CERTIFICATE OF APPROPRIATENESS

Property: 1010 Prairie Street, Lots 10 & 11, Block 56, SSBB Subdivision. The property includes a historic 28,500 square foot, three-story brick commercial building situated on an 11,250 square foot corner lot.

Proposal: Alteration – Install an internally lit acrylic letter and routed metal lit panel sign on the north elevation. The sign will be mounted to the existing non-original awning and will have overall measurements of 16’ wide and 28” in height. The sign will be a total of 34.333’ square feet in area.

Recommendation: Denial - does not satisfy criteria 4, 5, 9. The proposed interior lit plastic channel letters are not compatible with the building or the Main Street Market Square Historic District.

RENDERING – FRONT FACING PRAIRIE STREET

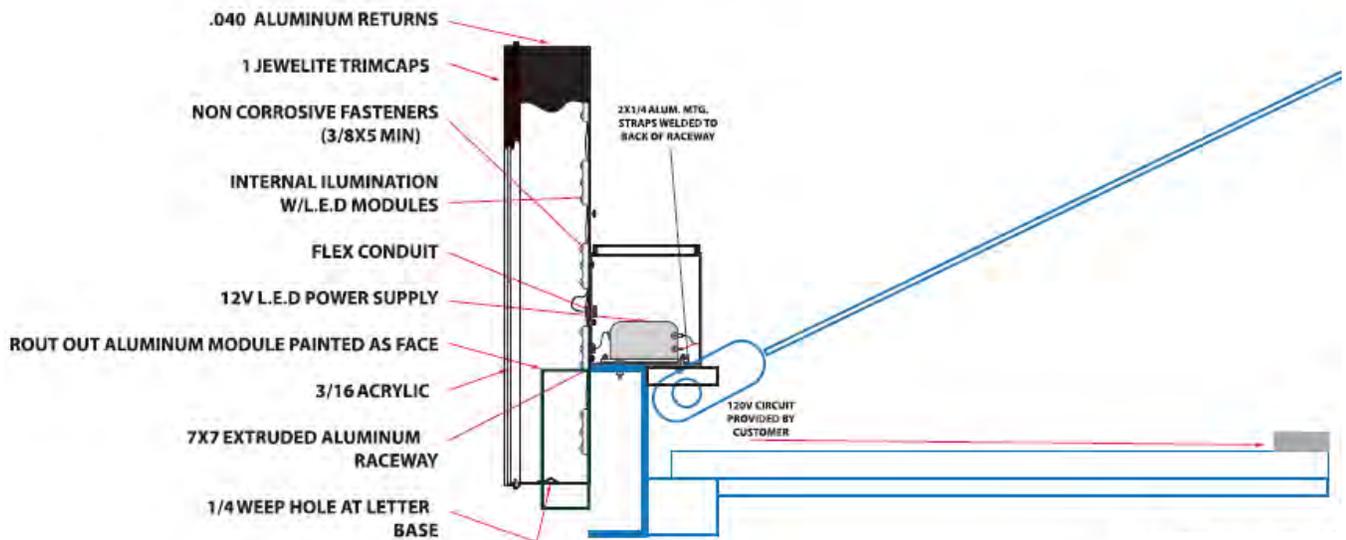
<i>The use of interior lit plastic channel letters do not preserve the distinguishing qualities or character of the building or the Main Street Market Square Historic District. According to the 'Downtown Houston Storefront & Streetscape Design Guidelines,' "The use of plastic box cabinet signs and plastic covered channel letters are not encouraged in downtown, and are not allowed on historic buildings or in the Historic District (pg. 25)." Staff recommends that the sign be indirectly illuminated using an external light source.</i> | |

<i>The use of interior lit plastic channel letters do not maintain or replicate distinctive stylistic exterior features or examples of skilled craftsmanship that characterize the building or the Main Street Market Square Historic District. According to the 'Downtown Houston Storefront & Streetscape Design Guidelines,' "The use of plastic box cabinet signs and plastic covered channel letters are not encouraged in downtown, and are not allowed on historic buildings or in the Historic District (pg. 25)." Staff recommends that the sign be indirectly illuminated using an external light source.</i> | |

The use of interior lit plastic channel letters are not compatible with material or character of the building or the Main Street Market Square Historic District. According to the 'Downtown Houston Storefront & Streetscape Design Guidelines,' "The use of plastic box cabinet signs and plastic covered channel letters are not encouraged in downtown, and are not allowed on historic buildings or in the Historic District (pg. 25)." Staff recommends that the sign be indirectly illuminated using an external light source.
